# Value Engineering Study

Final Report

## Hal Rogers Parkway KY 30 to KY 192 (MP 1.089 to MP 3.877) Laurel County Item No. 11-365.00

May 25, 2022

VALUE ENGINEERING (VE) PROPOSAL NO. 12

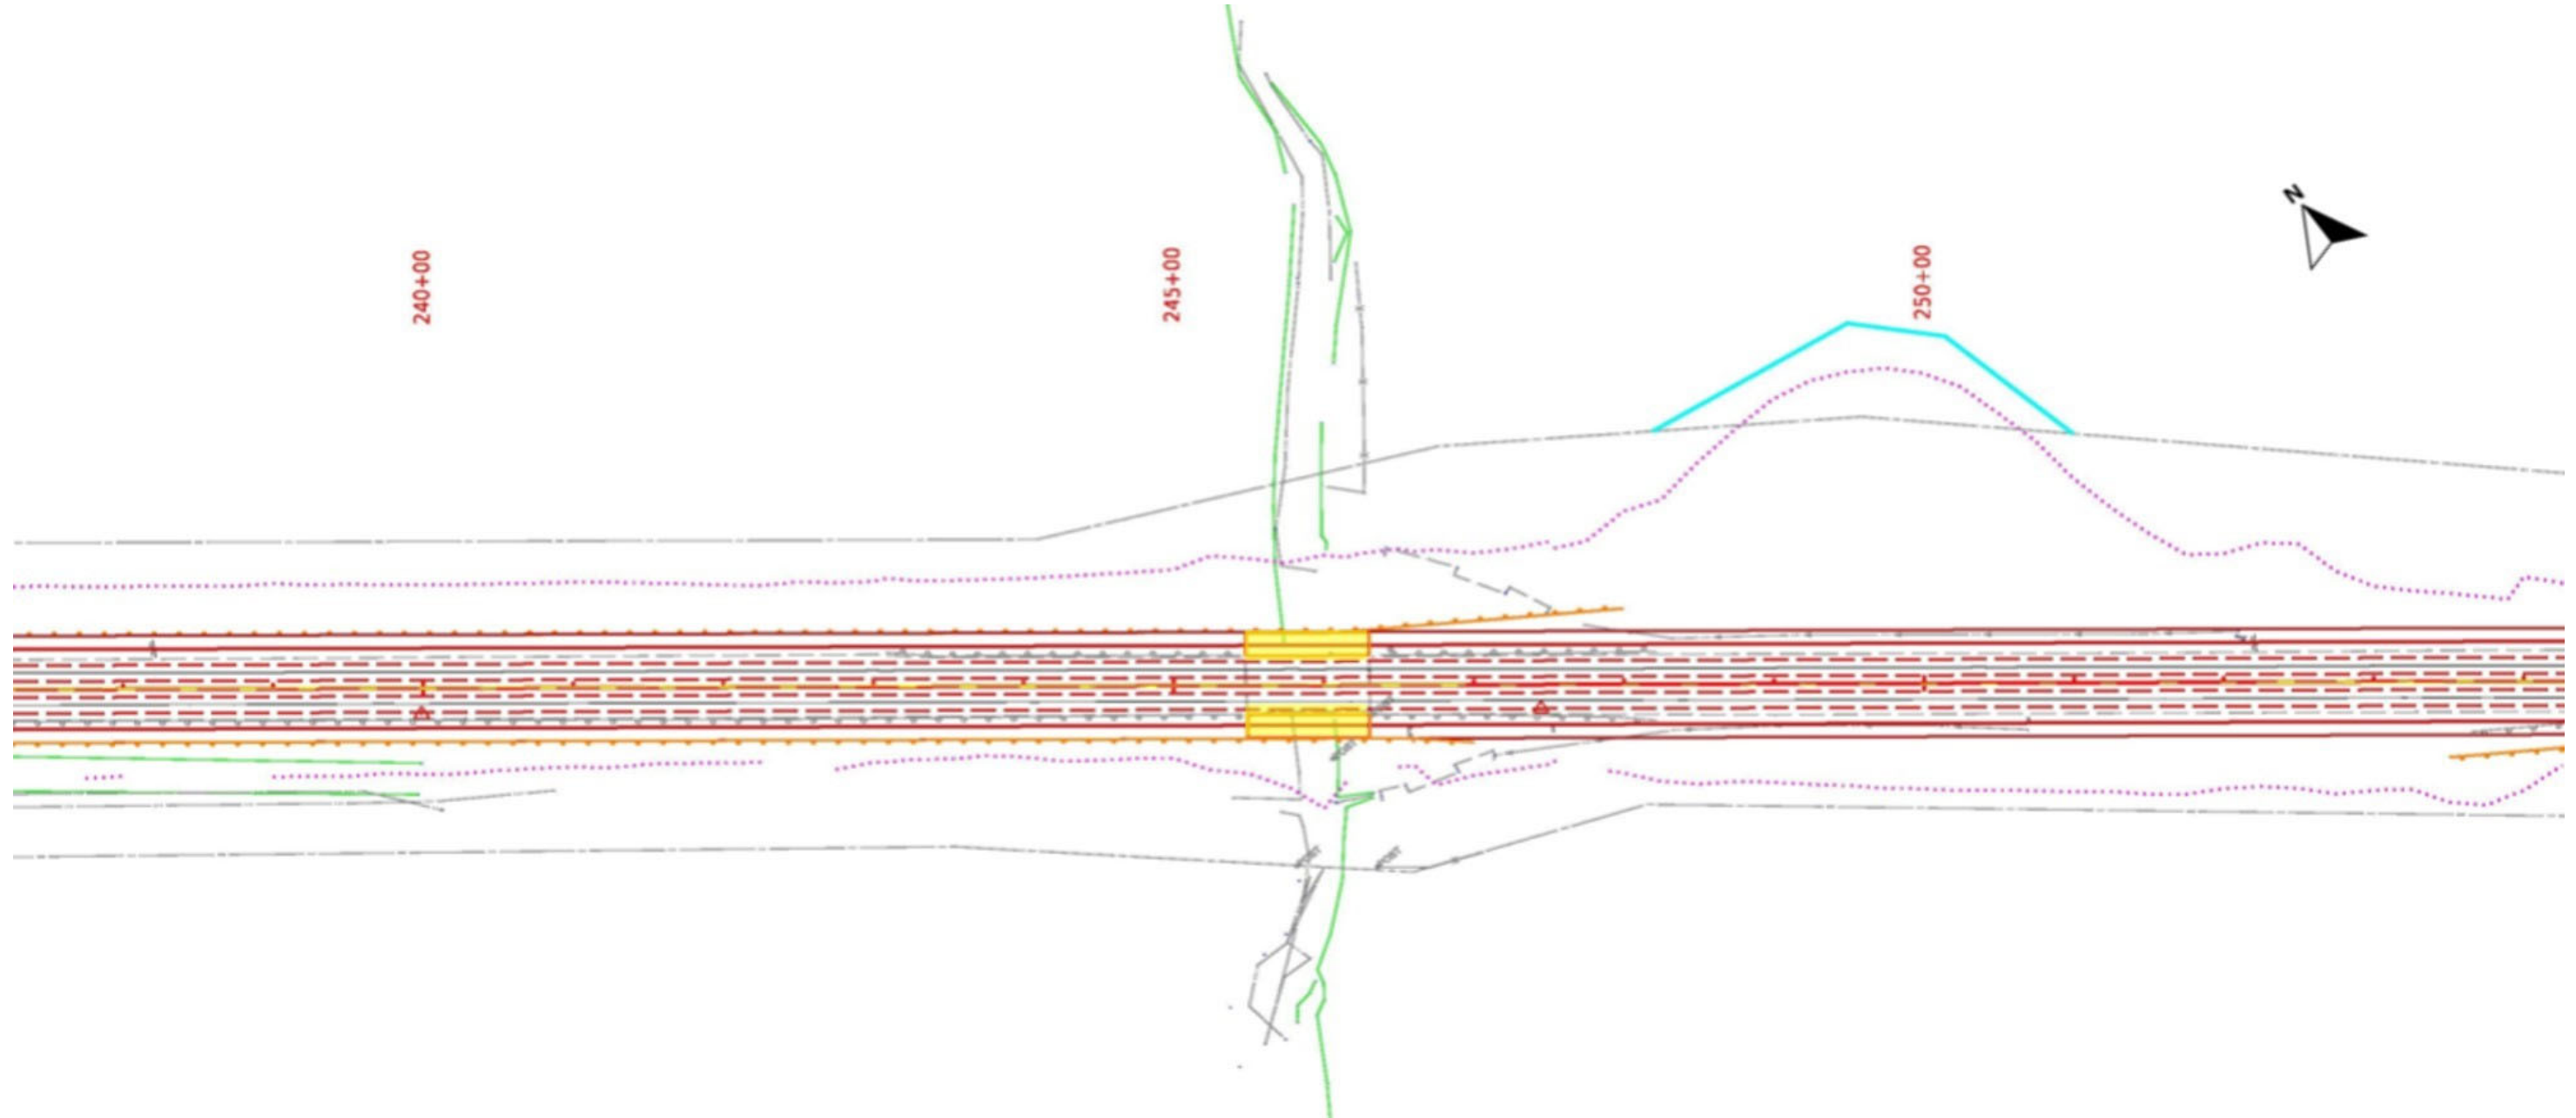
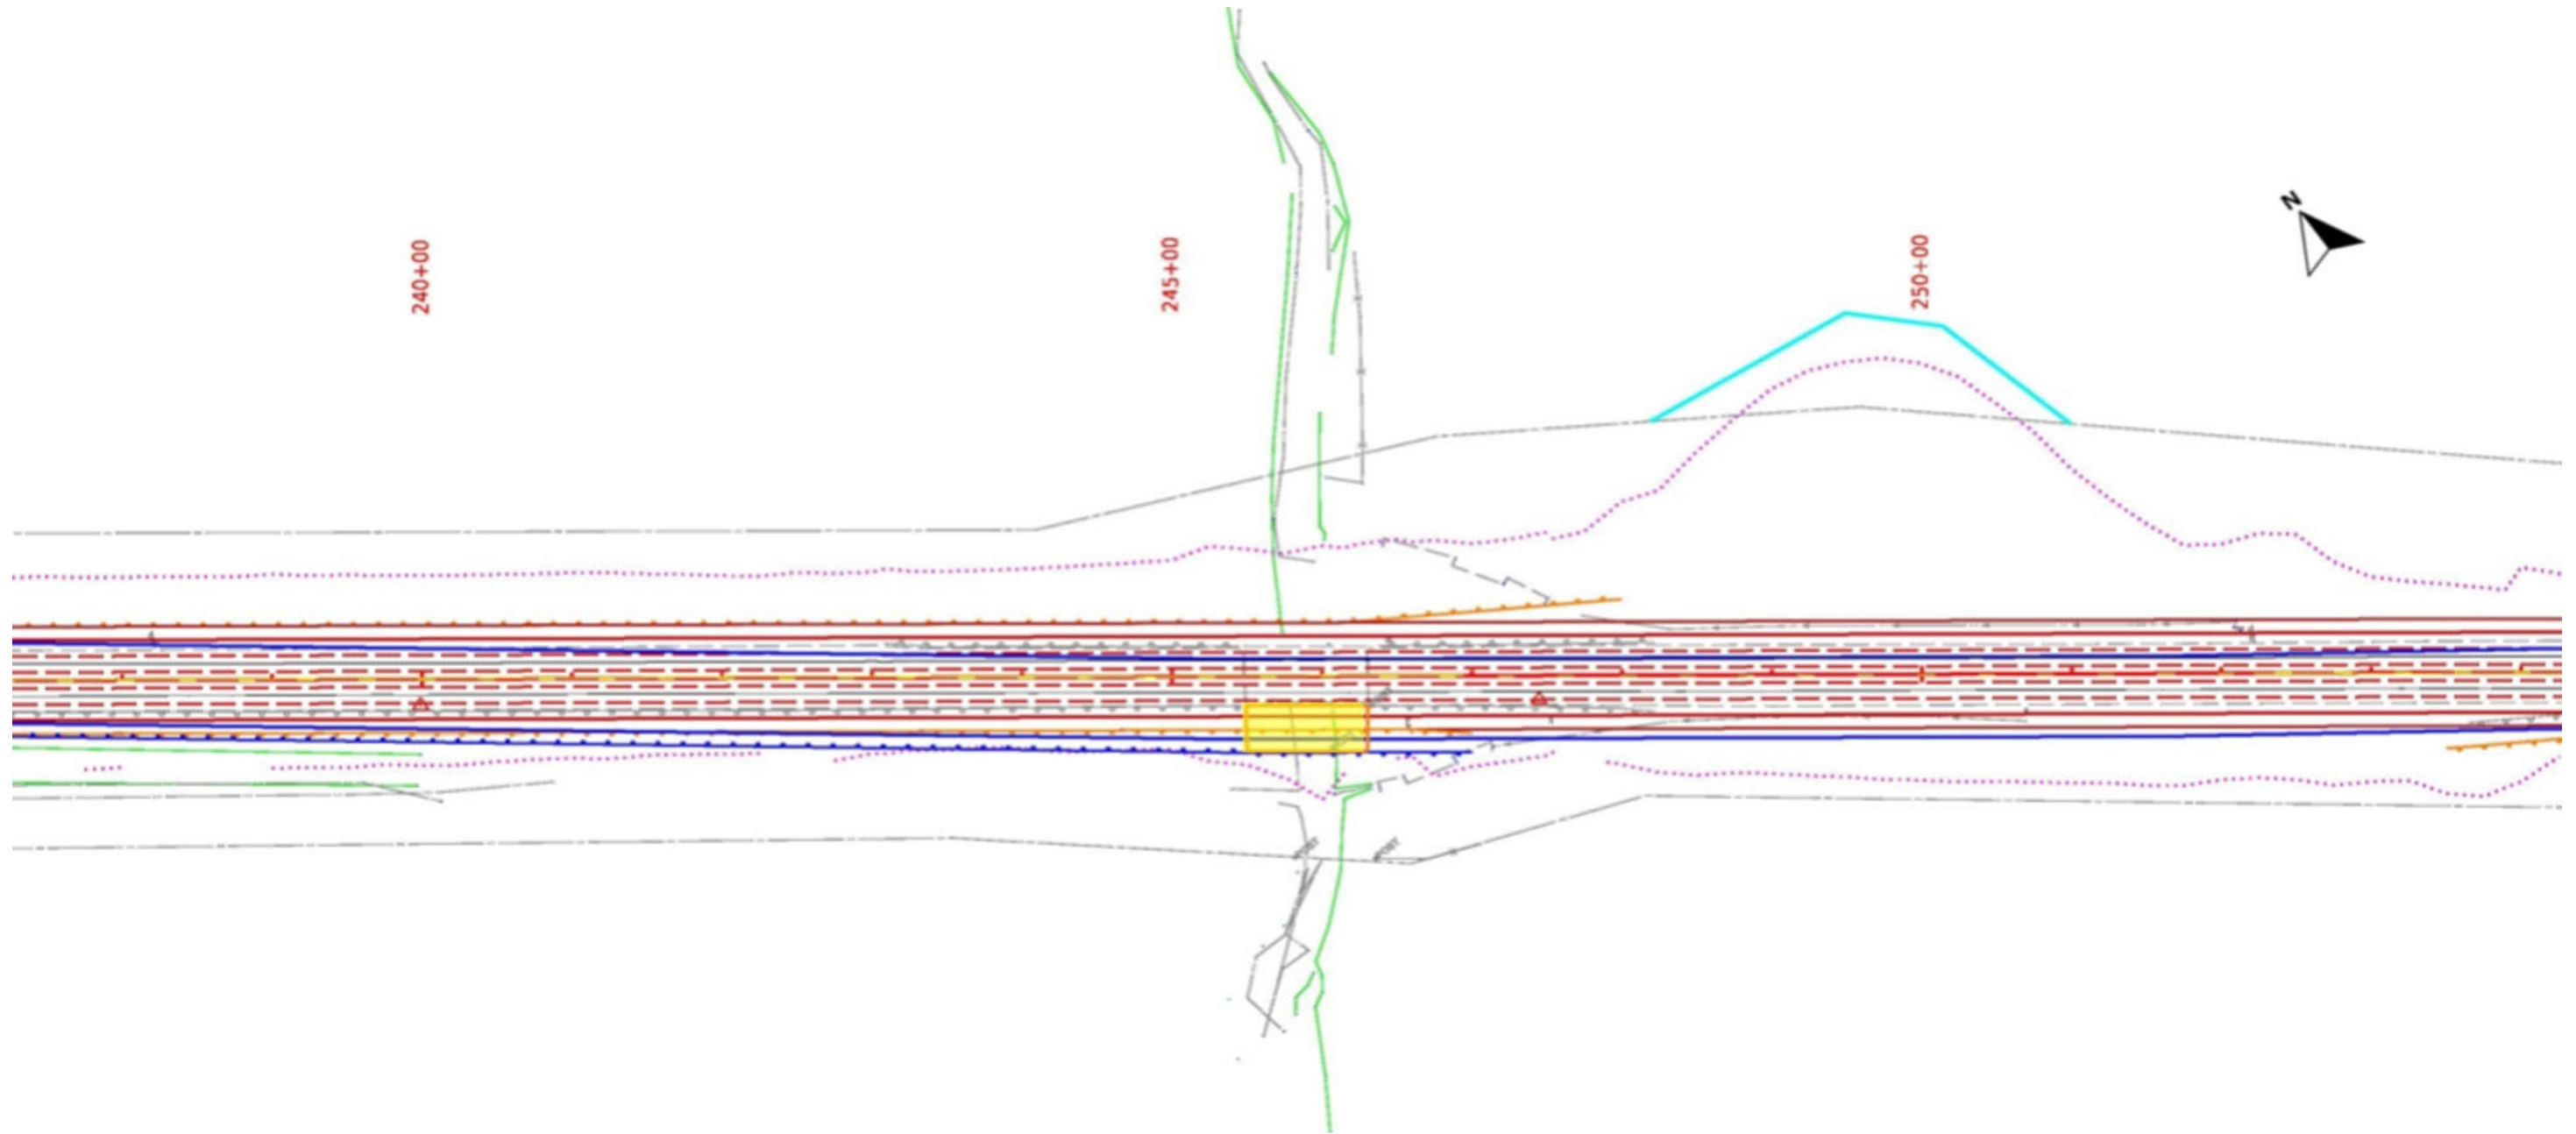
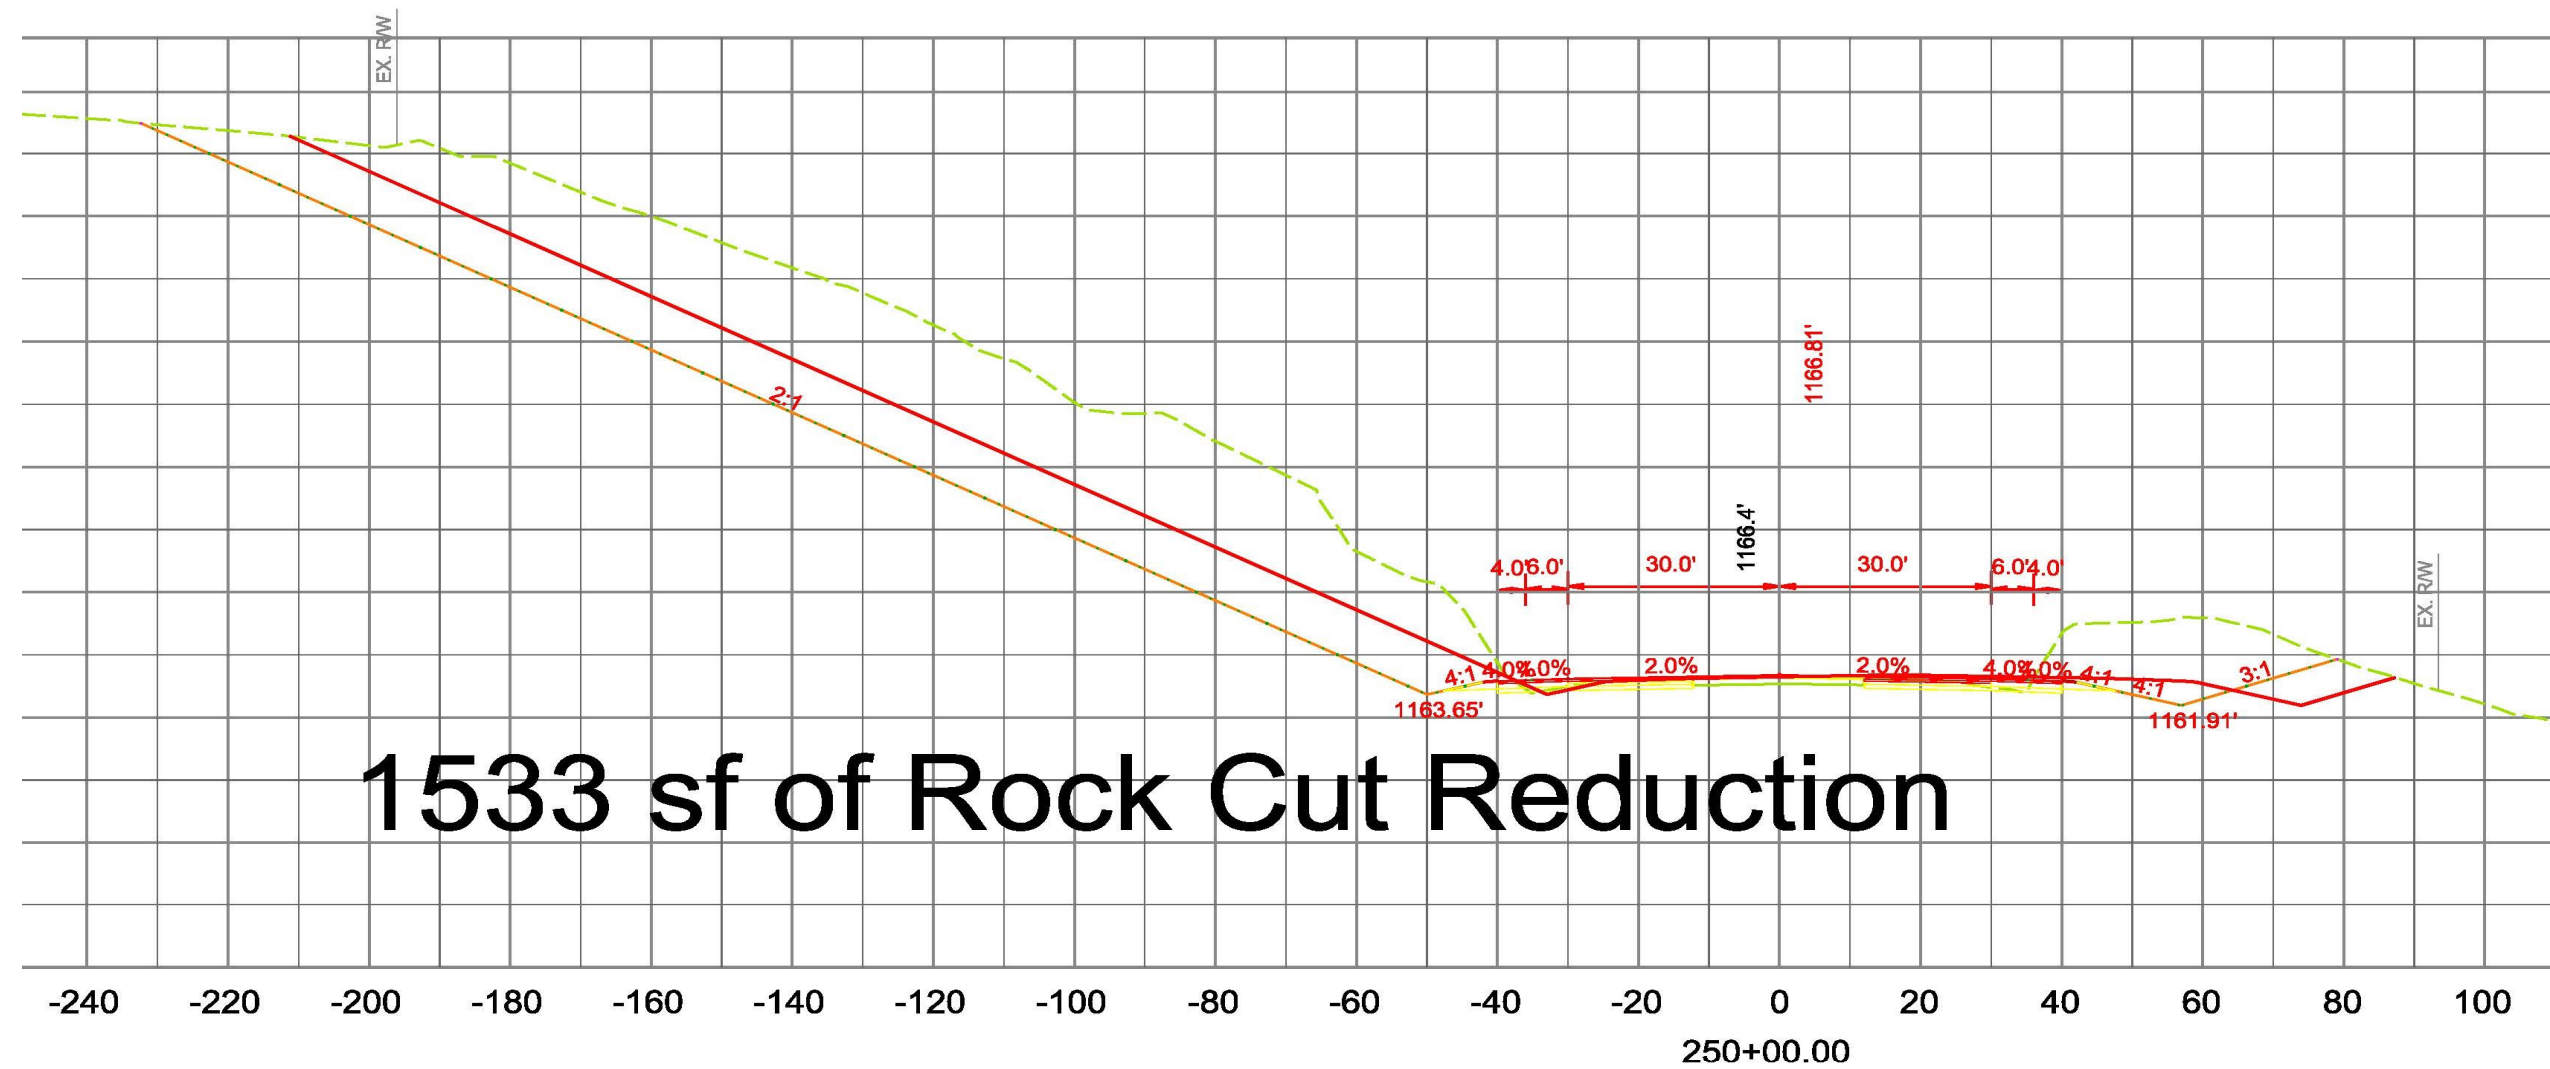
**TITLE** Shift alignment to south and widen one side only of bridge over Little Laurel River
